UNITED STATES  
NUCLEAR REGULATORY COMMISSION  
WASHINGTON, D. C. 20555

NOV 16 1978

Docket Nos: STN 50-546<sup>A</sup>  
STN 50-547<sup>A</sup>

SUBJECT: IMPLEMENTATION OF STAFF REVIEW REQUIREMENTS - MARBLE HILL  
NUCLEAR GENERATING STATION, UNITS 1 AND 2

FIG 1. PROPOSED DUCTILITY RATIO FOR BEAM COLUMNS

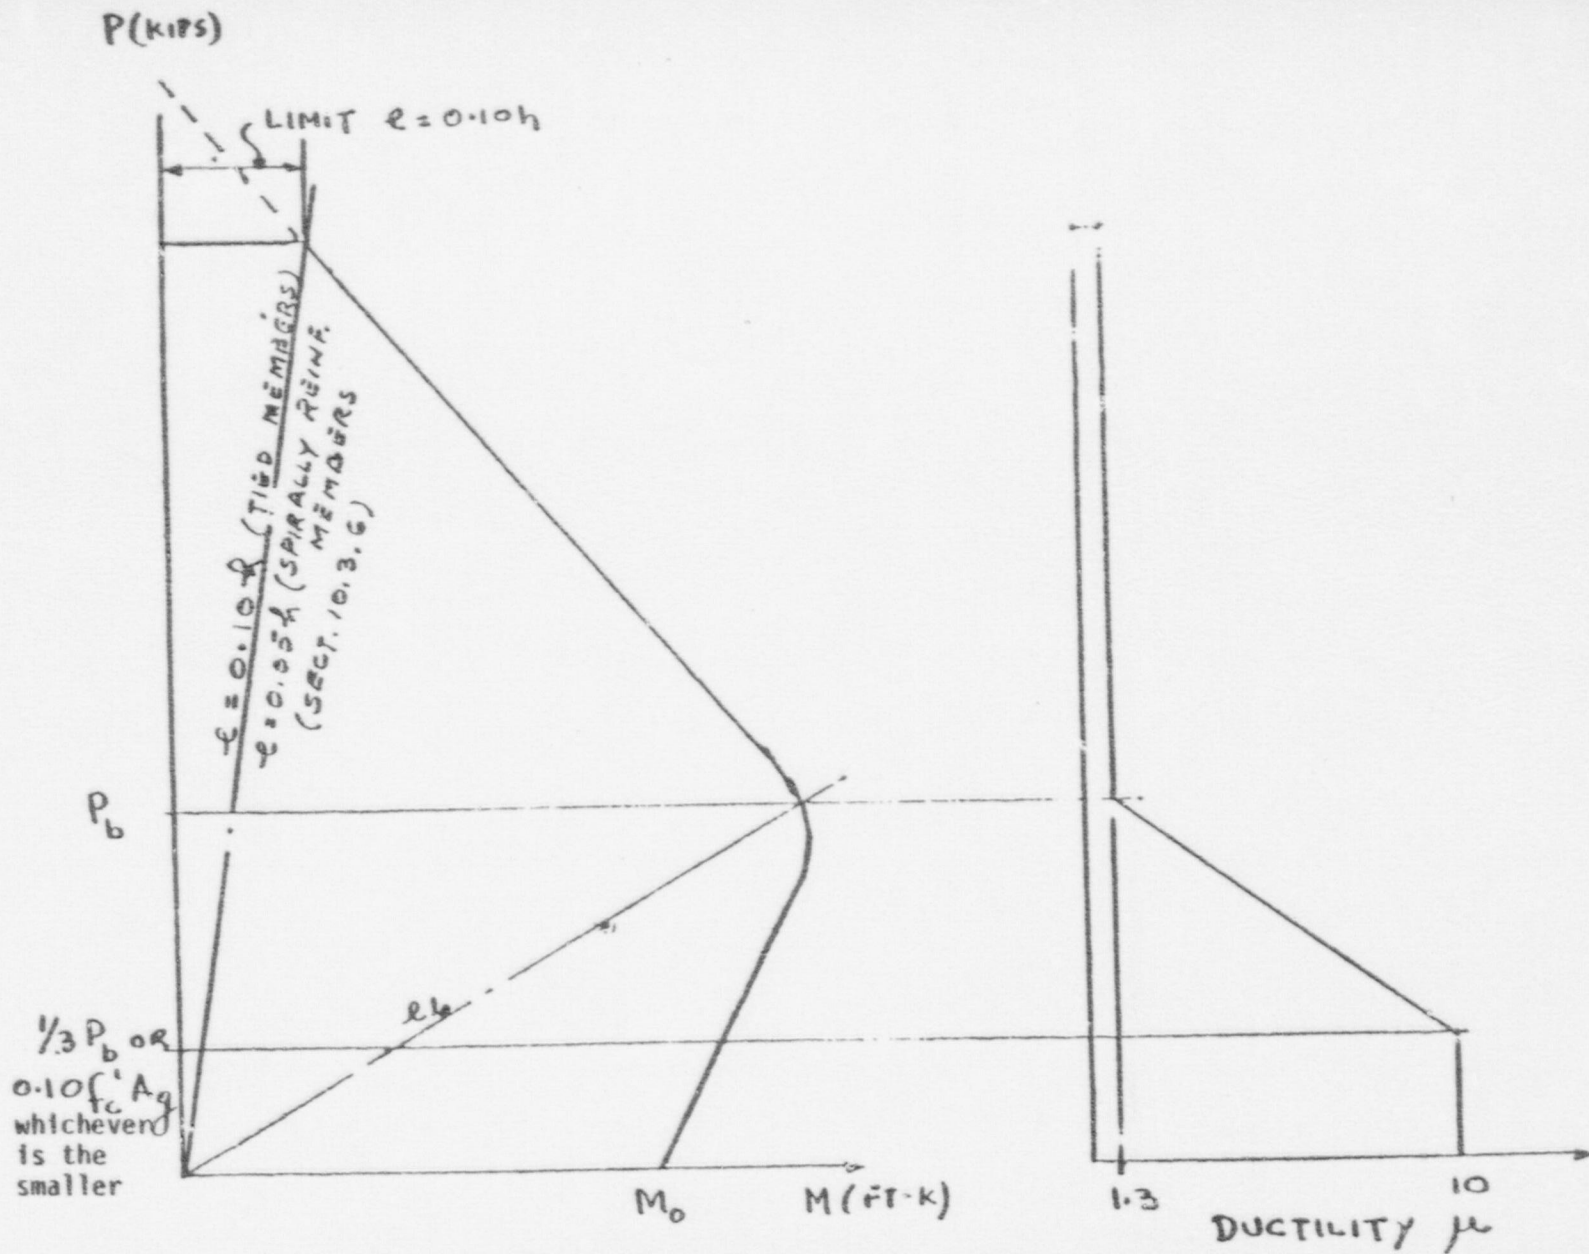
- 1.3 For beam-columns, walls, and slabs carrying axial compression loads and subject to impulsive or impactive loads producing flexure, the permissible ductility ratio in flexure should be as follows:

- (a) When compression controls the design, as defined by an interaction diagram, the permissible ductility ratio shall be 1.3.
  - (b) When the compression loads do not exceed  $0.1f_c'Ag$  or one-third of that which would produce balanced conditions, whichever is smaller, the permissible ductility ratio can be as given in Section 1.1.

- (c) The permissible ductility ratio shall vary linearly from 1.3 to that given in Section 1.1 for conditions between those specified in (a) and (b). (See Fig 1.)
